442.

Lifting Paratrooper weld failure

General image of component when assembled

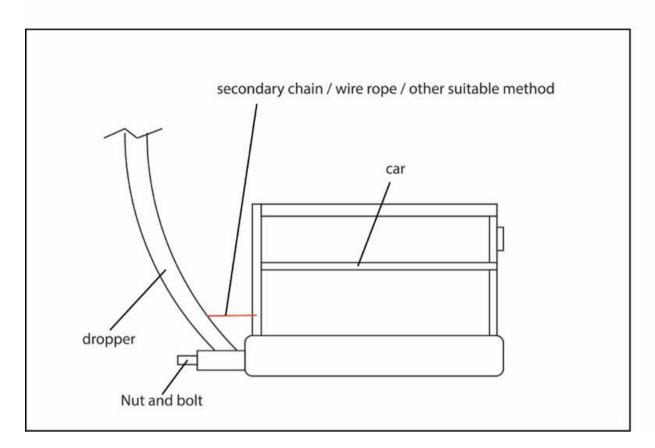
Consideration should be given to the addition of a secondary chain or wire rope between the car and dropper to remove this single point of failure. While this will not be as strong as the bolt, should the bolt fail the secondary only needs to stop the car sliding forward and out of the tube on the bottom of the dropper until the ride stops. (See figure 3)
